PANAMA CANAL AUTHORITY	VARIATION	PAGE 1 OF 3
1. REQUEST FOR PROPOSAL No.: RFP-76161	2. CONTRACT No.: CMC-221427	3. DATE: December 15, 2011
		4. VARIATION No.: 025

This Variation No. 25 is issued to change the Contractor's Limits at the Pacific Site as follows:

SK-P-A-0128

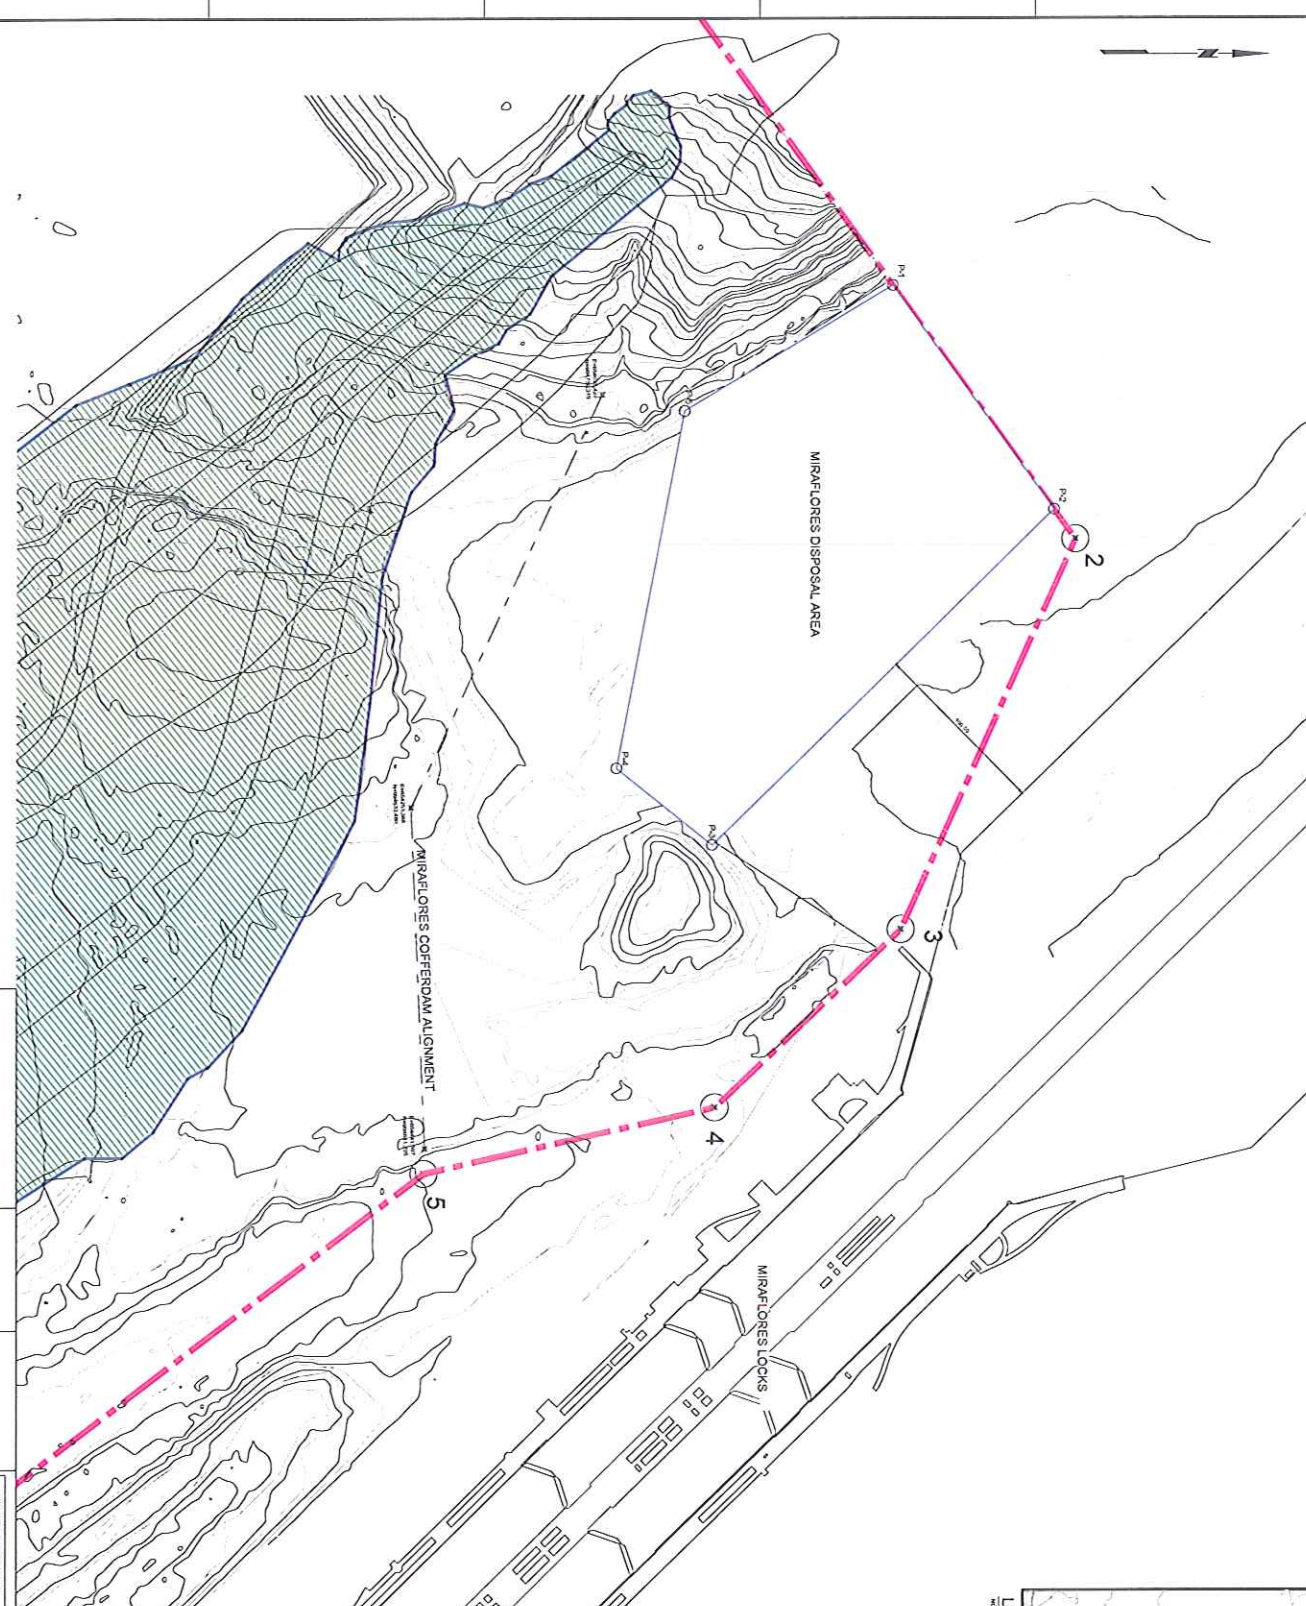
1. Aquatic Disposal Area in Miraflores Lake

Designate the Area shown in the attached Drawing SK-P-A-0128 and delineated by points P-01 to P-05 as an aquatic disposal site for the following purposes:

- Disposal of the dredged materials from the Miraflores Cofferdam foundation area.
- Placing of dredged materials well-away from the West Prism Line of the Canal, and as close to the West Bank as practical.

The Area is defined by the following coordinates:

Point	East	North
P-1	653965.2987	994899.6018
P-2	654088.8773	994988.8997
P-3	654274.3244	994799.9837
P-4	654231.7262	994747.2507
P-5	654034.3665	994784.8859

SK-P-A-0126

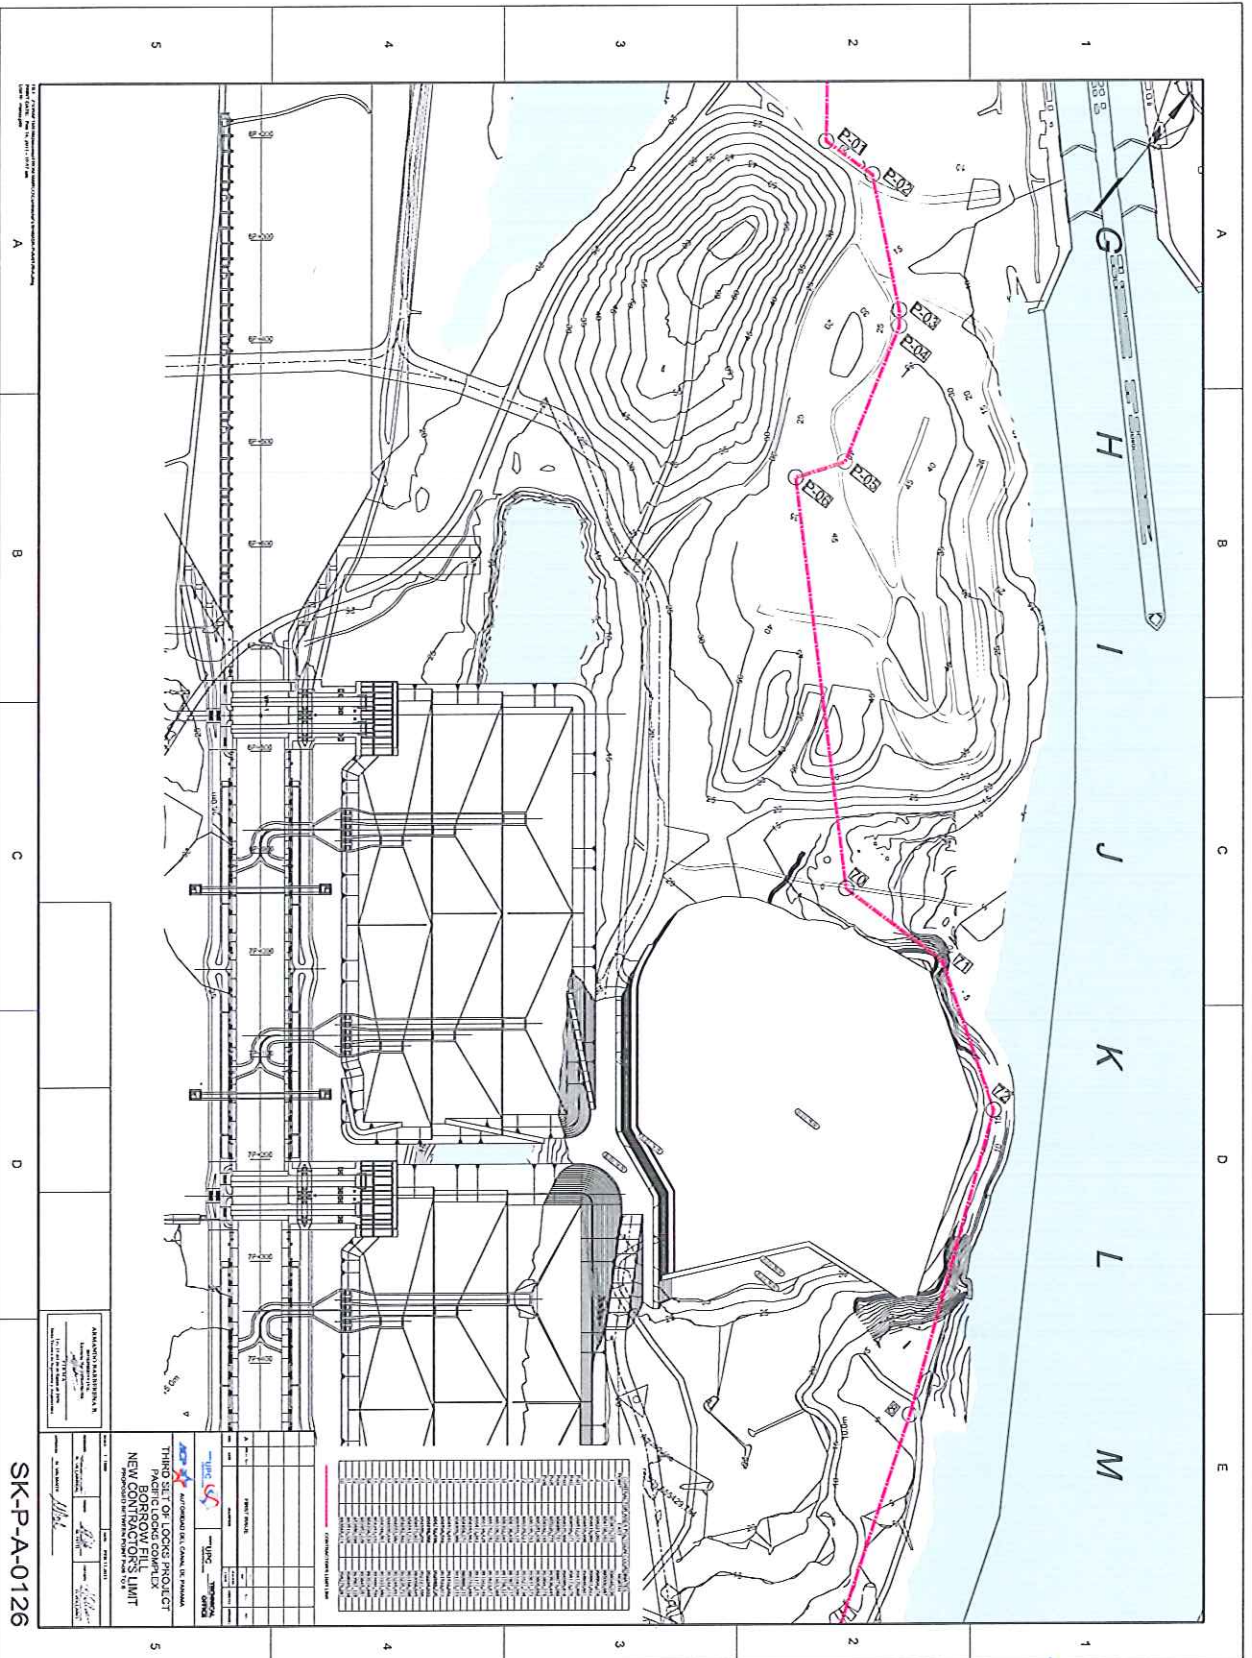
2. Aguadulce Hill Basalt Quarry

Extension of the Contractor's Limits on the North-East side of the Contractor's Polygon, to include the area which corners 70, 71, 72 and 8 are defined by the coordinates tabulated in the attached Drawing SK-P-A-0126

Point	East	North
70	655281.406	993608.652
71	655399.753	993611.373
72	655529.523	993527.734
8	655650.129	993242.990

SK-P-A-0136

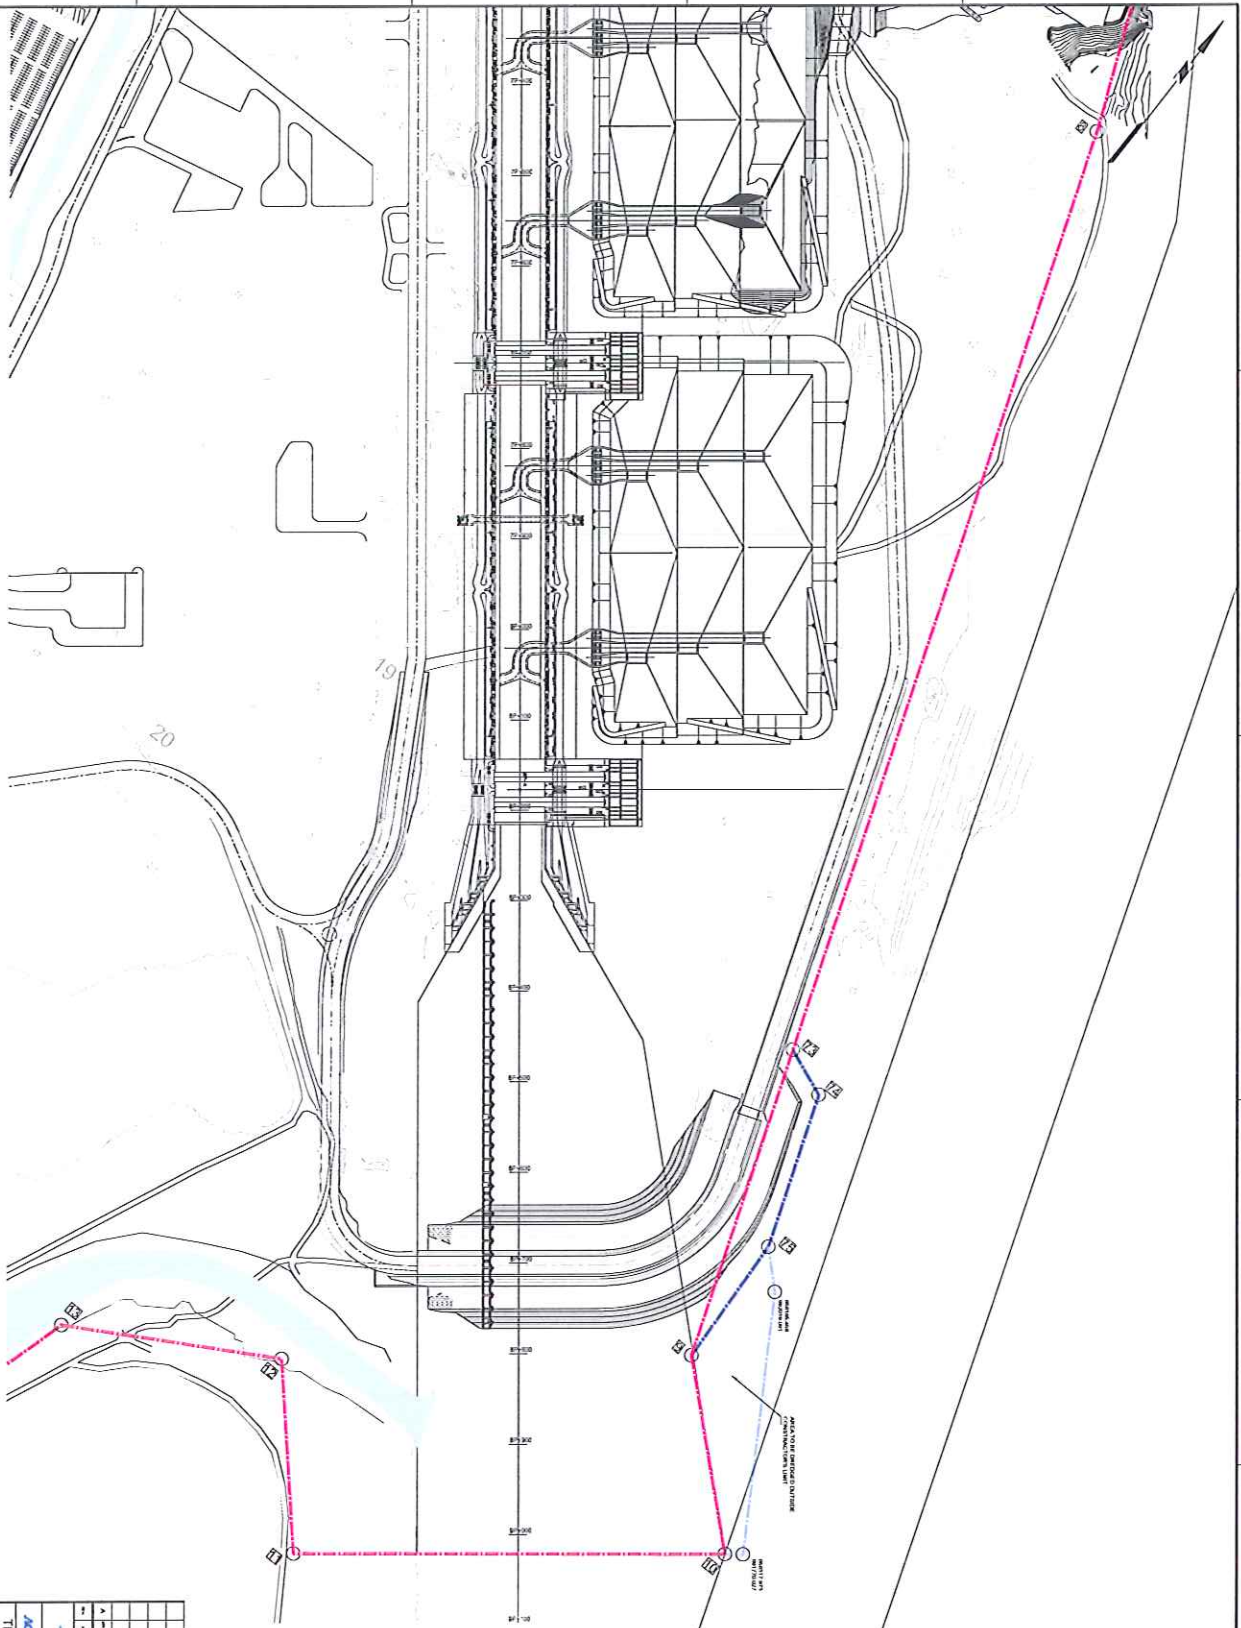
3. Pacific Approach Channel Cofferdam

Extension of the Contractor's Limits on the southeast corner of the Contractor's Polygon, to include the area which corners 73, 74, 75 and 9 are defined by the coordinates tabulated in the attached Drawing SK-P-A-0136.

Point	East	North
73	656015.028	992240.757
74	656068.528	992219.490
75	656128.841	992053.831
9	656136.459	991907.217
